- Item 1. Sliding Selector Shaft and Detent Assembly - Speed Triple 1050, Speed Triple 1050 R, Sprint GT and Tiger 1050 from engine number 563847
- Item 2. Triumph Diagnostic Software support for Windows® 8 and Windows® RT operating systems - All

### Item 1.

**Description:** Sliding Selector Shaft and Detent Assembly

**Models affected:** Speed Triple 1050, Speed Triple 1050 R, Sprint GT and Tiger 1050 from engine number 563847

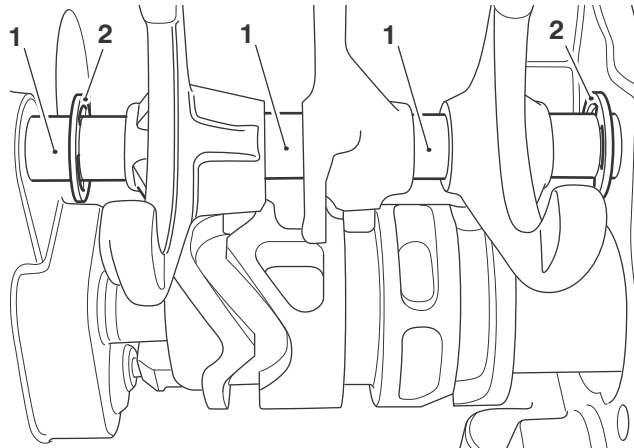
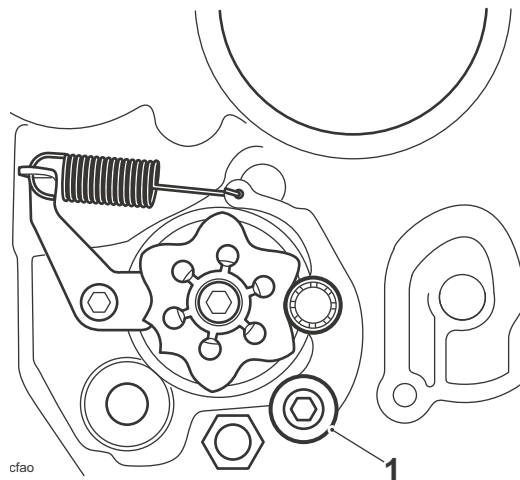
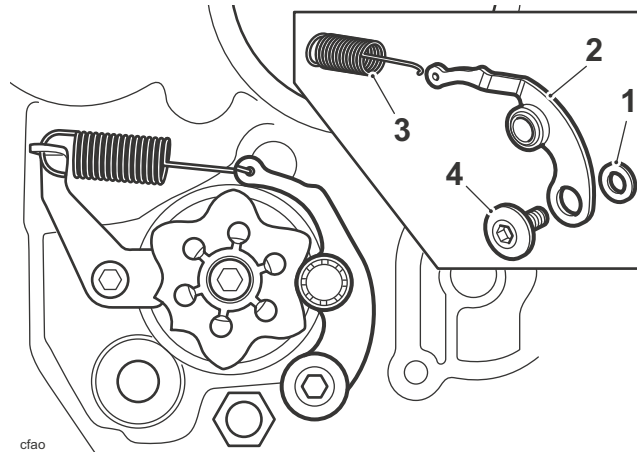
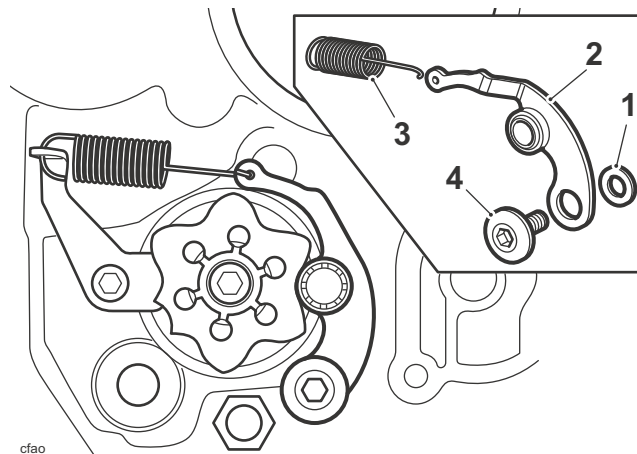
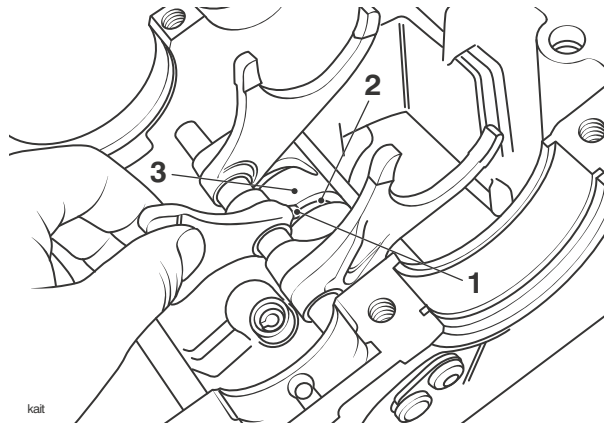
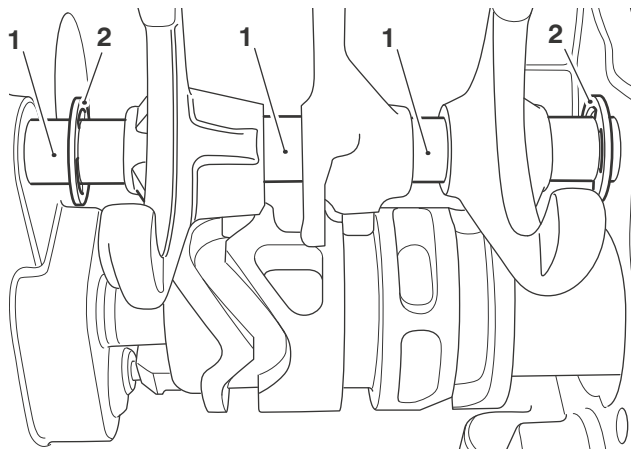
A new sliding selector shaft and detent assembly has been introduced on the above models from engine number 563847. The new shaft is secured into the crankcase with E-clips and is not retrofittable.

- Lubricate with clean engine oil and fit the detent wheel engaging the wheel with the locator pin in the selector drum. Tighten a new fixing to **12 Nm**.
- Assemble the detent arm as noted on removal and place up to the crankcase.

- The selector shaft is symmetrical and can be installed in either orientation.**
- Lubricate with clean engine oil and push the selector shaft into the crankcase from the keeper plate end. As the shaft is inserted lubricate and locate the selector forks. Ensure the forks are fitted in the positions noted during removal.

- **If the blanking screw is removed for any reason, clean and apply one drop of ThreeBond 1305 to the threads. Tighten the screw to 22 Nm.**
4. Refit the E-clips to the selector shaft.

**Description:** Handlebar End Weights

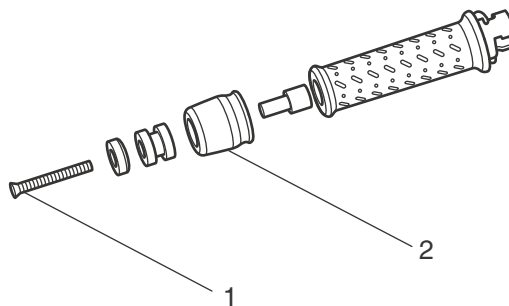
The torque figure for the handlebar end weight fixing has changed to **5 Nm** on the above models.

**Description:**                    **Steering Damper**

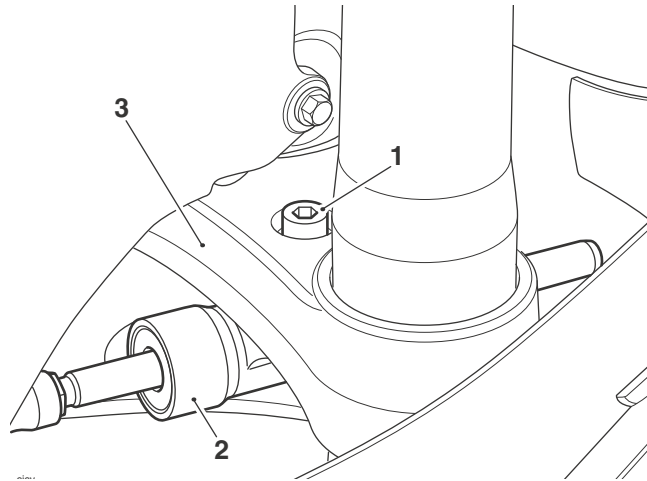
The torque figure for the steering damper fixing to the lower yoke has changed to **20 Nm** on the above models.

**Tightening Sequence**

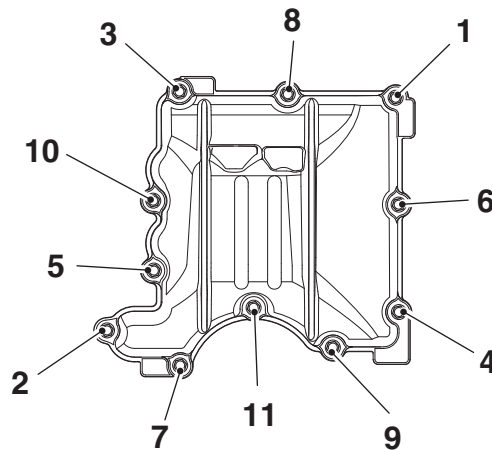
The torque figure for the sump fixings has changed to **10 Nm** on the above models.

1. Tighten fixings 1 to 11 in the sequence shown below to **10 Nm**.
2. Re-tighten fixings 1 and 2 to **10 Nm**.

**1. Warning label**

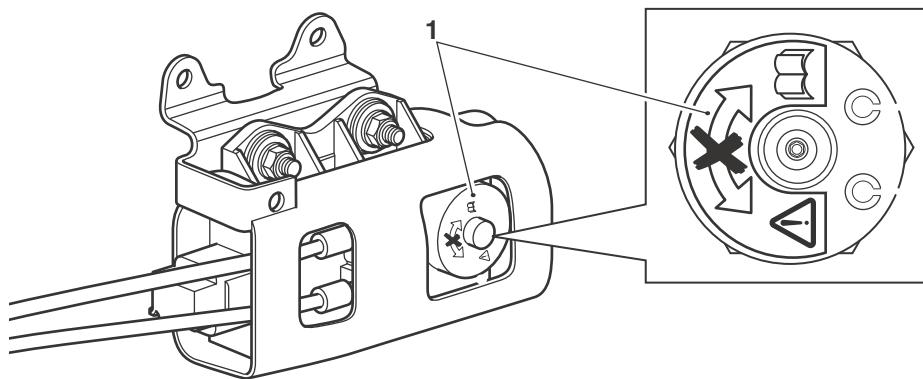
The Daytona 675 and 675 R from VIN 564948 are now fitted with a new design of exhaust butterfly valve actuator. The new internal mechanism means it is no longer possible to rotate the pulley wheel without causing damage to the internal drive gear.

If for any reason the pulley wheel is manually rotated internal damage will result and a new actuator will be required.

Therefore when checking the operation of the exhaust butterfly valve actuator, always use the Function Test feature on the Triumph Diagnostic Tool.

Do not rotate the pulley on the exhaust butterfly valve actuator. Rotating the pulley will damage the internal components of the actuator.

**Description:**                **ABS Bracket**

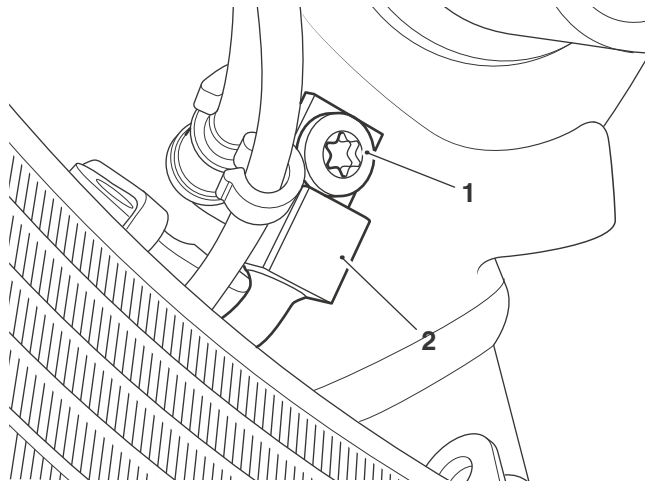
The torque figure for the ABS headstock brake pipe union fixing has changed to **15 Nm** on the above models.

- **Models already in service need not be re-tightened unless the fixings have been loosened or removed.**
- **If removed for any reason the fixing must be replaced.**

**Description:** Immobiliser Screws

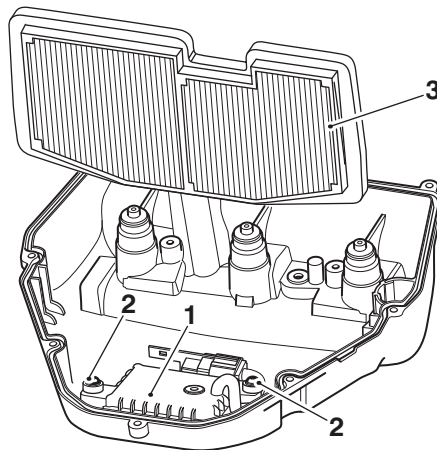
The torque figure for the engine immobiliser fixings has changed to **1.5 Nm** on the above models.

**Description:** Coolant Expansion Tank

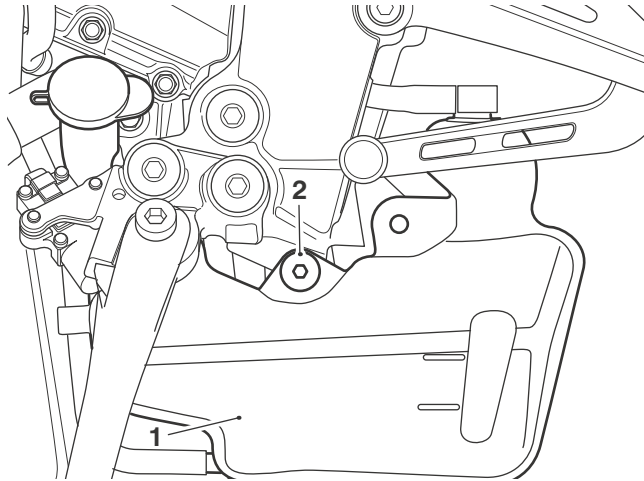
The torque figure for the coolant expansion tank fixing has changed to **7 Nm** on the above models.

**Description:** Seat Lock

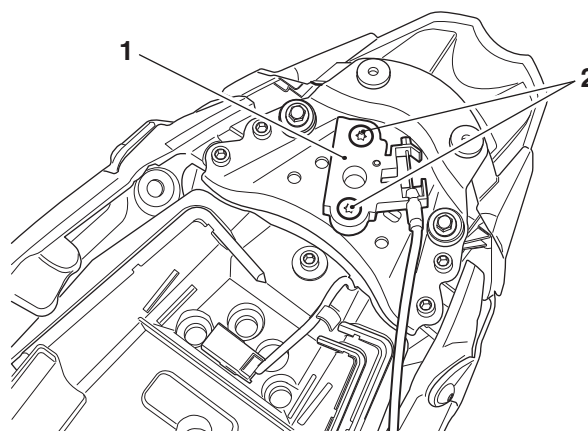
The torque figure for the seat lock fixings has changed to **5 Nm** on the above models.

**Tightening Sequence for the Clamp Fixings**

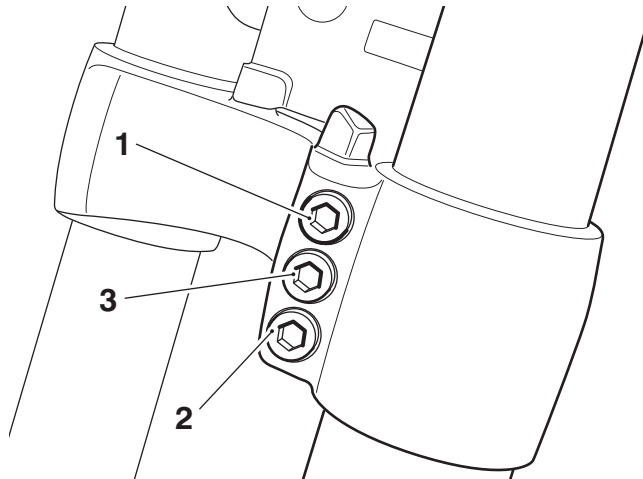
The tightening sequence for the lower yoke clamp's three fixings has changed. Tighten the lower yoke clamp fixings to **25 Nm** in the sequence shown below.

**Description:** Silencer Heat Shield Fixings

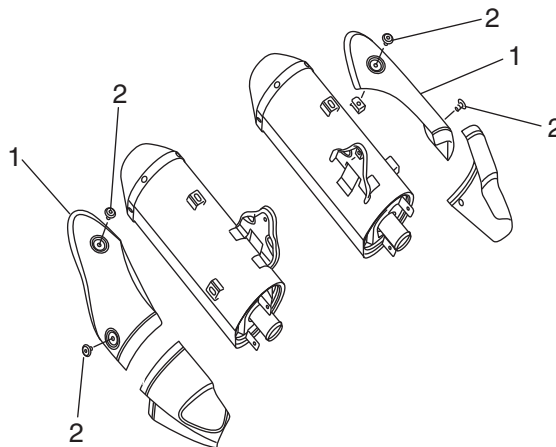
The torque figure for the silencer heat shield fixings has changed to **8 Nm** on the above models.

**Description:** Twist Grips Bodies

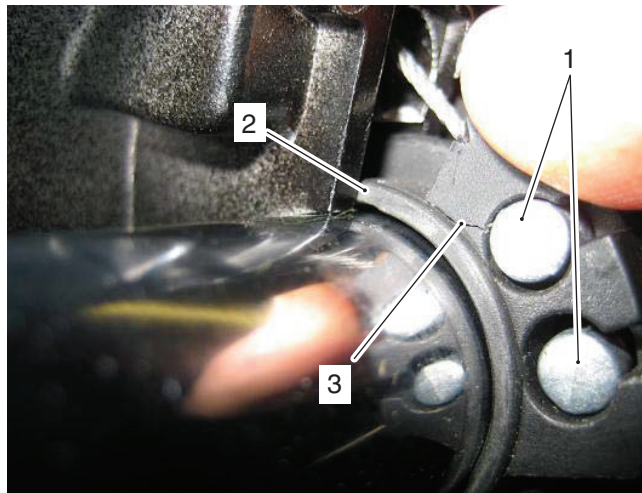
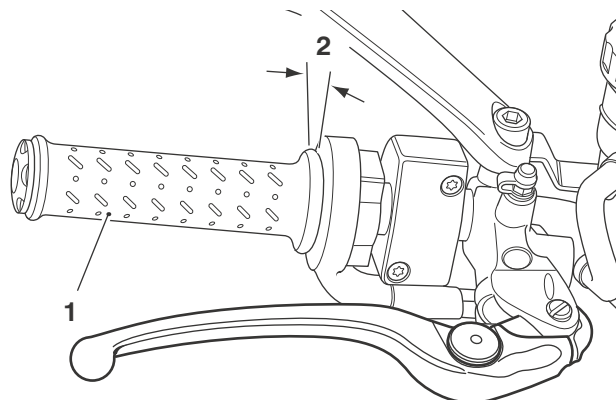
It has come to our attention that a small number of twist grip bodies are cracking in the area where the throttle cables are attached to the twist grip. See picture below.

Following our investigations, we note that this damage will only occur when throttle cable free play has been incorrectly adjusted and the free play has been reduced or removed completely.

The owner's handbook and service manual both state that there must be 2-3 mm of free play in the throttle cables which is measured at the throttle grip.

Refer to the service manual when fitting or adjusting the throttle cables.

**Description:** Brake Lines

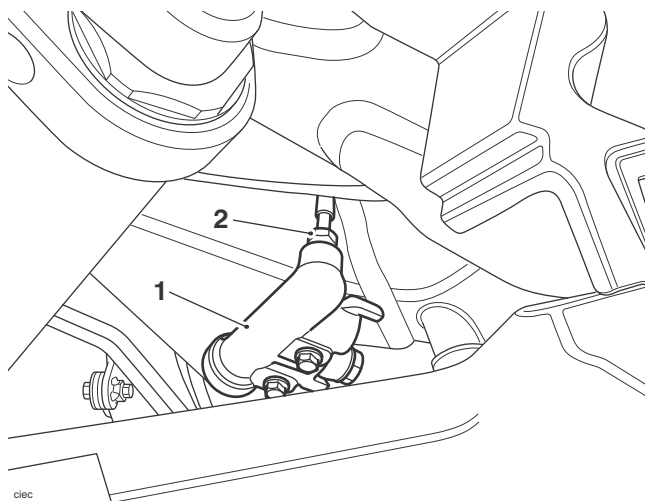
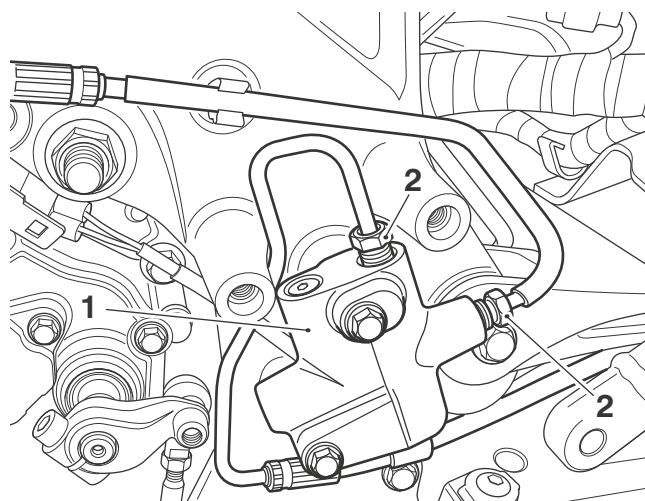
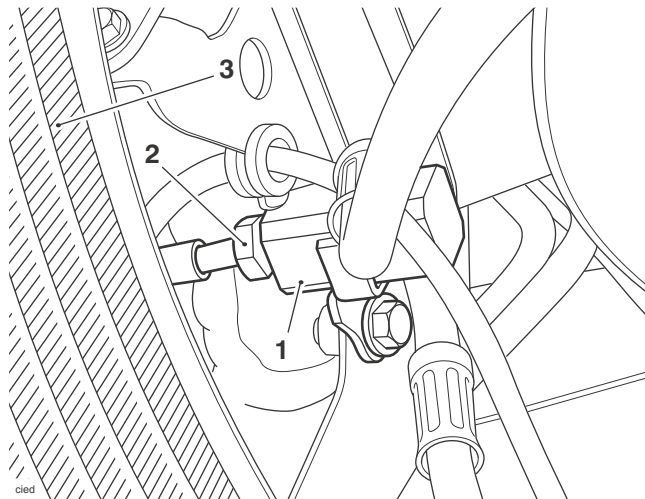
The torque figure for the brake line unions listed below have changed to **15 Nm** on the above models.
